**Site assessment**

**River Esk – Ruswarp**

**23/08/16**

**Undertaken by Gareth Pedley - Conservation Officer**

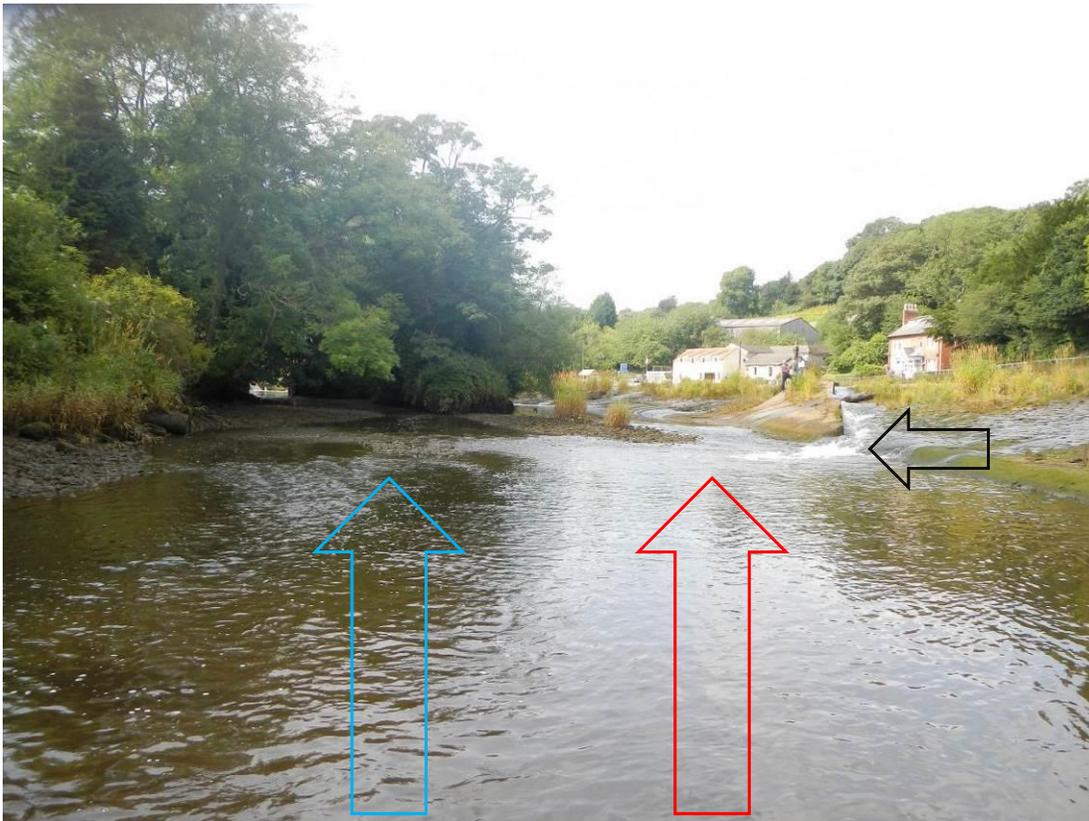
At higher flows, when the turbine is discharging, more water will flow down both channels, with possibly slightly more flowing down the RB channel, owing to the turbine's orientation. Observation d/s of the island when the turbine is discharging would be beneficial in ascertaining the associated impact upon attraction flows; however, the LB channel is likely to be an important route for fish migration at all flows, especially at higher flows when water overtopping the weir increases attraction to the LB channel.

**Figure 5. Looking u/s at the two possible approach routes around the island, from the d/s end. The longer, shallower access route to the RB channel (blue arrow) and the narrower, deeper access route to the LB channel (red arrow), via the deeper area of the d/s river channel. Note the additional attraction to the LB channel provided by the baulk pass (black arrow).**

**Figure 6. Looking d/s at the discharge from the baulk pass (blue arrow), creating a major attraction towards the baulk and, when the baulk is not passable, to the LB channel (red arrow). Note the wider, shallower, less attractive approach to the RB channel (far right of shot).**

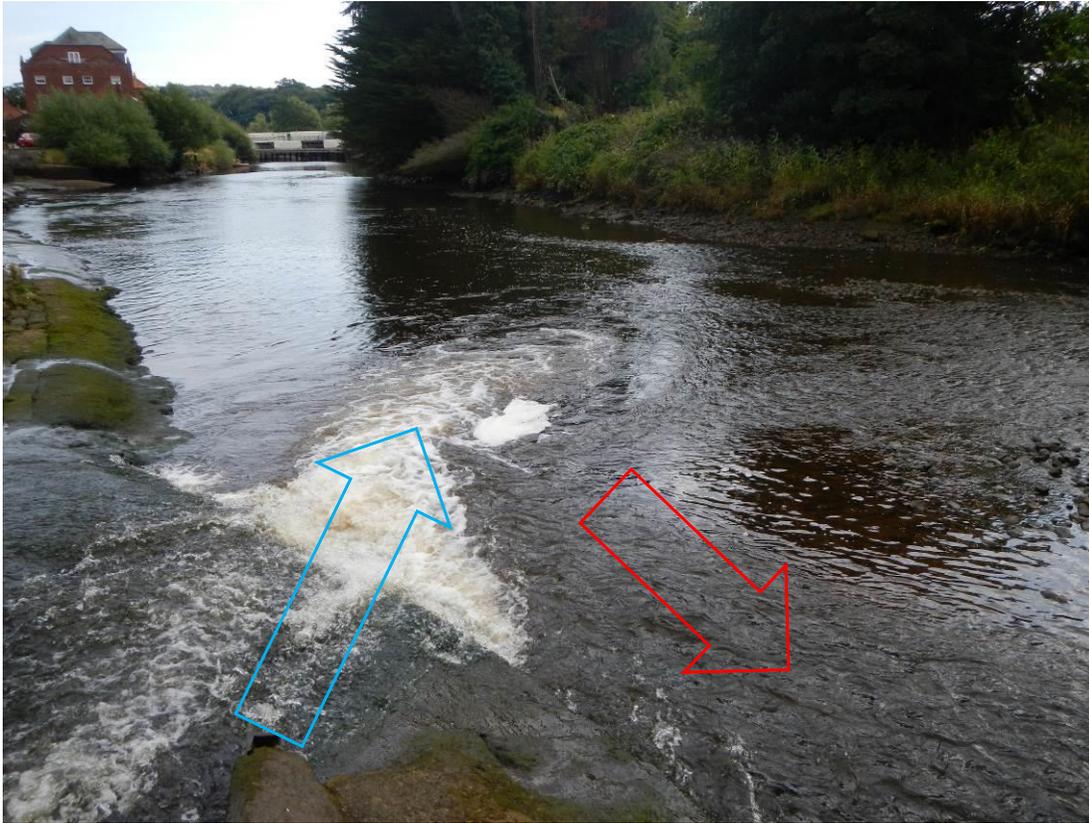
There could be an argument for closing the baulk pass completely and optimising passability at the Larinier pass. This could consolidate some of the attraction flows, but not once the weir is overtopping and attraction increases along the weir toe and LB channel. There is also the consideration that the efficacy of the Larinier has not been established and the baulk pass may remain an important migration route at higher flows. Passage via the Larinier pass may also be delayed by attraction to the hydropower turbine discharge, whereas fish that find the baulk pass, and are capable of ascending it (of sufficient size and power) may not experience such delays.
